RE: DOV/21/01822 - Cross Road, Deal – Southern Water Consultation

APPENDIX A UPDATED OUTLINE SURFACE WATER DRAINAGE STRATEGY

Drawing Title
Indicative Surface Water Drainage Strategy DRAFT

Drawing No. **10-01** Rev. **P3**

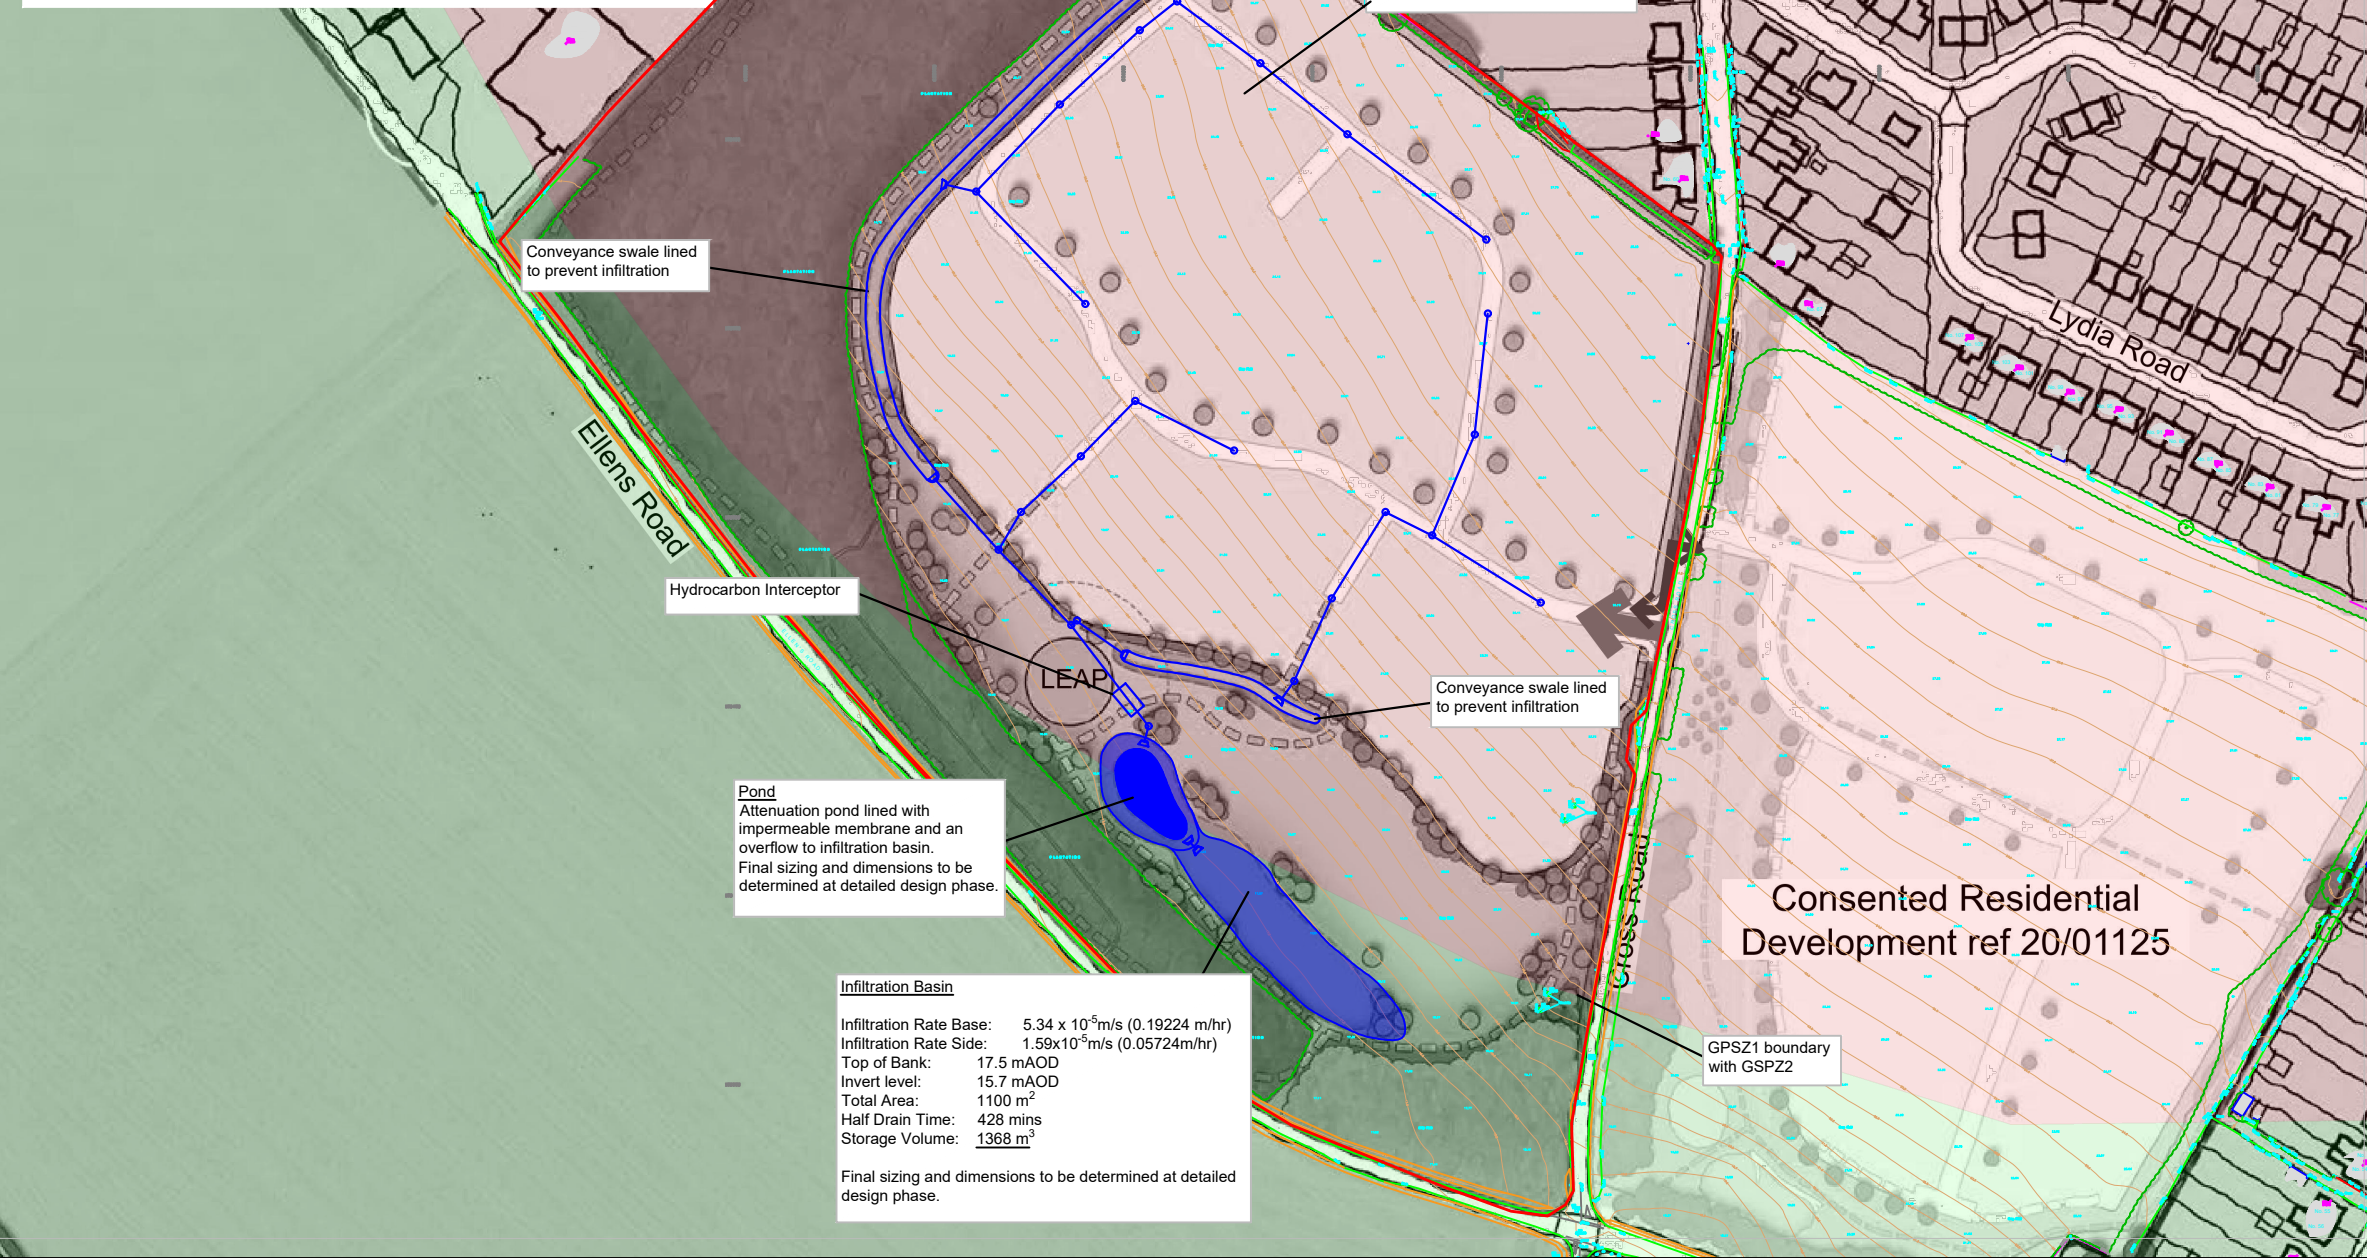
I refer to the recent online consultation meeting between RSK and Southern Water on 20/06/2022, attended by Colin Whittingham of RSK, and William King and Richard Gamble of Southern Water. Southern Water had expressed initial concerns that the outline surface water drainage strategy provided in the Flood Risk Assessment 680074-R1(01)-FRA was proposing to discharge via infiltration to the ground into an area of Groundwater Source Protection Zone (GSPZ) 2 and of close proximity to GSPZ 1. It was noted during that meeting that the aquifer under the site supplied drinking water to large areas surrounding the site and a direct connection into the shallow aquifer (unconfined chalk with little/no superficial) could be detrimental should pollutants and suspended solids be mobilised directly into the aquifer. Southern Water wanted reassurances that a surface water drainage strategy would be designed to mitigate against a pollution event at both construction and post-development stages.

It was agreed that the surface water drainage strategy should ensure that all drainage passes through a number of treatments including lined permeable paving, filter strips or lined swales, an oil interceptor, pre-treatment basin/pond and through to the final infiltration basin. This does not deviate largely from the original outline drainage strategy (P2) submitted in 680074-R1(01)-FRA; however, amendments have been included to show repositioning of the hydrocarbon interceptor to take all flows from the site and a note made to confirm the use of lined permeable paving within the proposed developable area. The updated drainage strategy (P3) is included in **Appendix A**.

RSK Geosciences is to provide a high level hydrogeological assessment with proposed mitigation measures for the construction phase of the development for the current outline planning application. Southern Water will expect to receive a detailed assessment (including a Construction Environmental Management Plan) once final construction details are known and will seek to secure this through a planning condition.
